# UNITED STATES PATENT AND TRADEMARK OFFICE

<b>Office Action Summary</b>	<b>Application No.</b> 10/800,716	<b>Applicant(s)</b> HIJIKATA ET AL.	
	<b>Examiner</b> Michael B. Shingleton	<b>Art Unit</b> 2815

Claims 1, 4, 5, 16, 19, 20, 22 and 24 are rejected under 35 U.S.C. 103(a) as being unpatentable over Ishii et al. US 5,280,641 (Ishii).

Figure 4A of Ishii

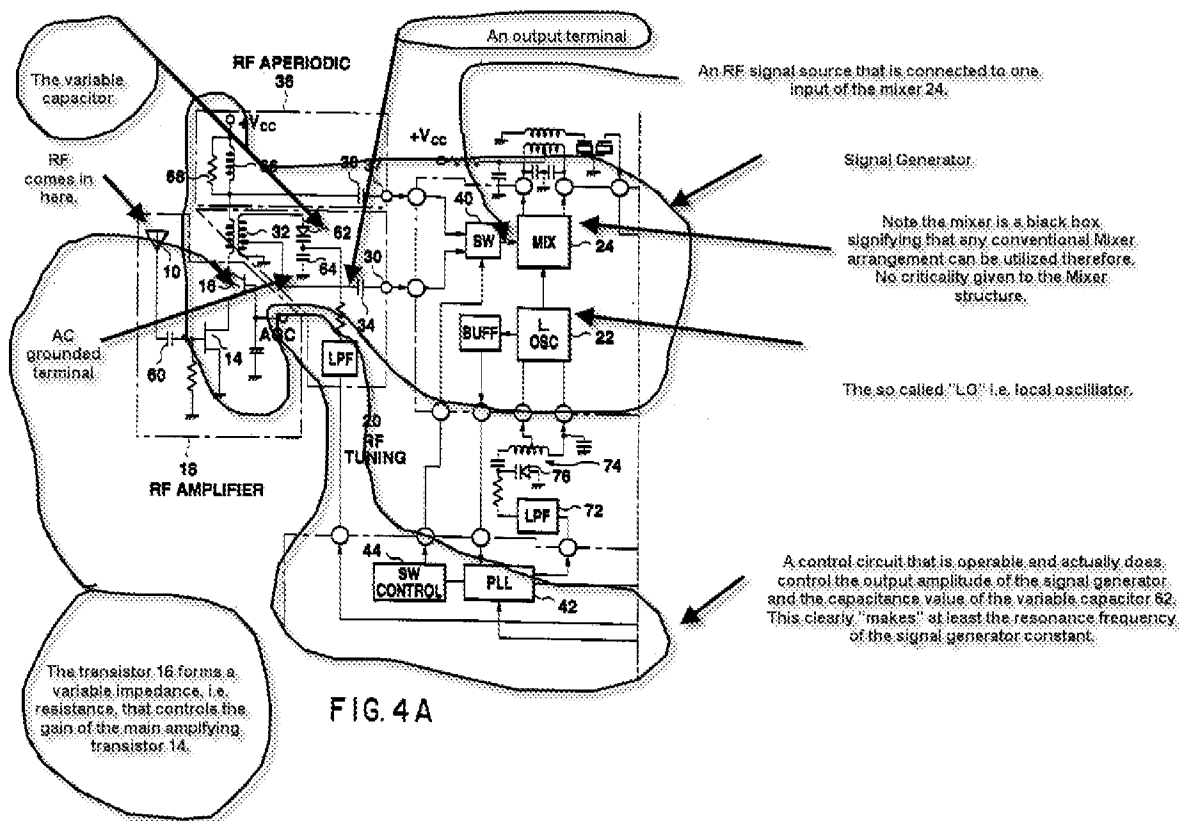
Figure 4A and the relevant text of Ishii discloses a variable gain amplification circuit having a signal generator (gain variable signal generator) as indicated above whereby element 16 forms a variable resistor element that is also part of the load for the source/drain of the main amplifying transistor 14. Also the resistor 68 is shown in Ishii as a load for the amplifier or signal generator and while this element is shown as a non-adjustable element to make an element adjustable has long been held as “not a patentable advance”, i.e. it would have been obvious to one of ordinary skill in the art. See *In re Stevens*, 101 USPQ 284 (CCPA 1954). Thus it would have been obvious to one of ordinary skill in the art at the time the invention was made to have made the element 68 adjustable so as to allow for the tuning of the circuit so as to select the optimum or workable range for the device as is known in the art and as is within routine skill. Element 62 is a variable capacitor that is connected between the output terminal, i.e. the tap on secondary 32 and an AC ground, i.e. note the ground symbol. As indicated in the above the circuitry that provides the control signal for the variable capacitor and the AGC signal forms the claimed control circuit. The signal applied to the variable capacitor 62 can be called part of the “gain setting”. The control signal  $V_T$  for the variable capacitor clearly controls the capacitance value of the variable capacitor 62. The claims now recite, i.e. have been amended to recite that the capacitance *makes* either the cutoff frequency or the resonance frequency of the signal generator constant. This is what happens in Ishii. Note that although the signal  $V_T$  may vary for a short period the value the signal does settle down to a single value and remains there till the tuning point is changed thereby making the resonance frequency of the signal generator constant that also corresponds to the maximum point of signal strength.

Some of the claims recite that the RF signal source has a “signal band”, i.e. bandwidth??? equal to or larger than 100MHz. Ishii is silent on this particular bandwidth setting. However, selecting the values and quality of the passive elements like the capacitor is merely the discovery of the workable range for the circuit of Ishii. It would have been obvious to one having ordinary skill in the art at the time the invention was made to have selected the values of the circuit elements in Ishii to achieve a 100MHz or greater bandwidth, since it has been held that where the general conditions of a claim are disclosed in the prior art, discovering the optimum or workable ranges involves only routine skill in the art. *In re Aller*, 105, USPQ 233.

The signal generator of Ishii also includes a Mixer 24 but Ishii is silent on the details of the construction of the mixer itself. Also Ishii includes a Local Oscillator 22, i.e. “LO”??? It is well known that one art recognized equivalent form of mixer is one that has a variable gain. Accordingly, it would have been obvious to one of ordinary skill in the art at the time the invention was made to have replaced

the mixer 24 of Ishii with one that has a variable gain because as the Ishii reference is silent on the exact details of the construction of the mixer 24 one of ordinary skill in the art would have been motivated to use any art-recognized equivalent mixer such as a variable gain mixer.
